**CITY OF
PARRAMATTA**

Submission

To the Department of Planning, Industry
and Environment

In response to the public exhibition
of the 2020 revised draft master
plan for the Carter Street
Precinct

Figure 20: Minimum Building Setbacks

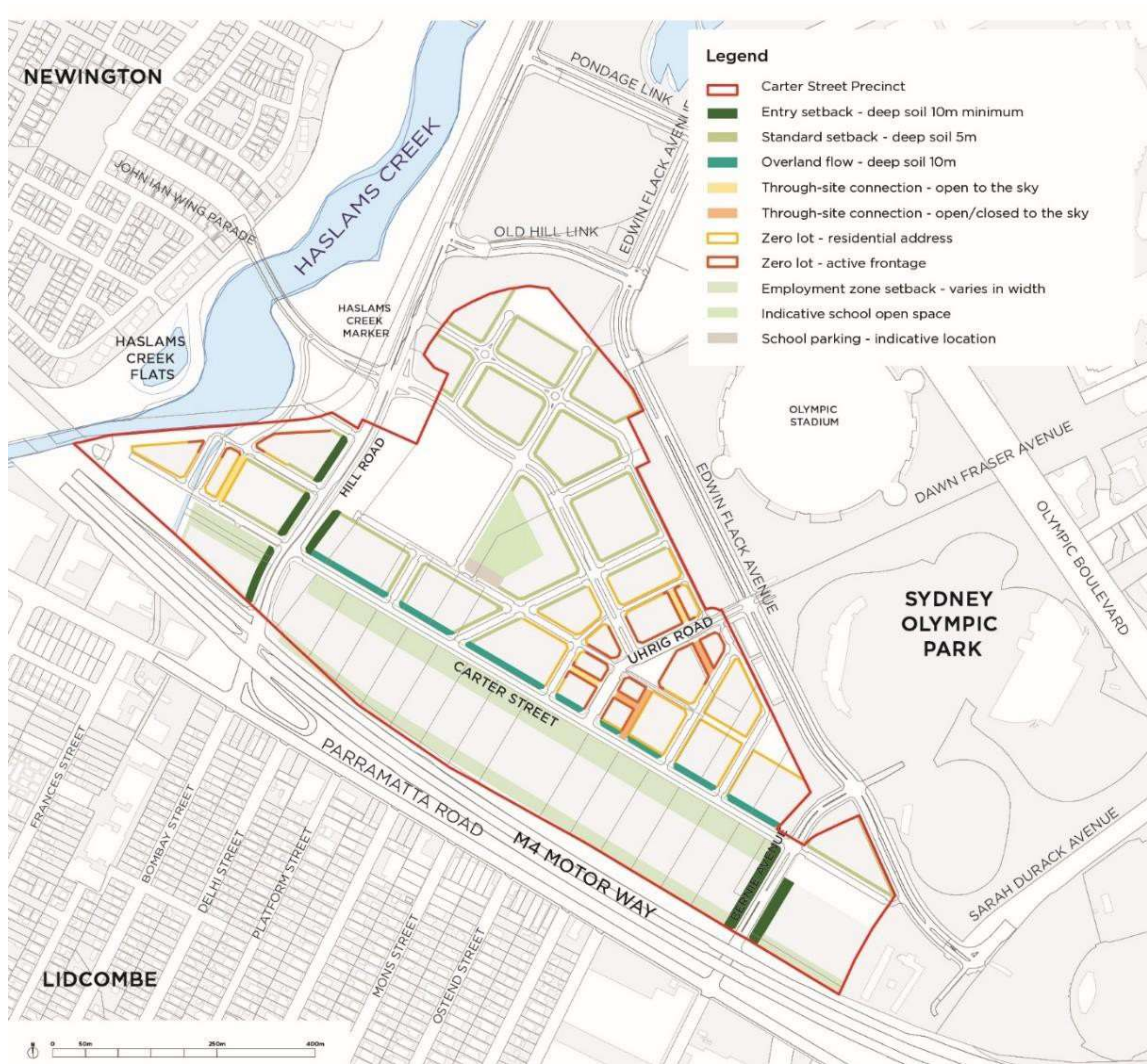
[Amend minimum building setbacks in accordance with the commentary and mark up drawing in the master plan comments.](#)
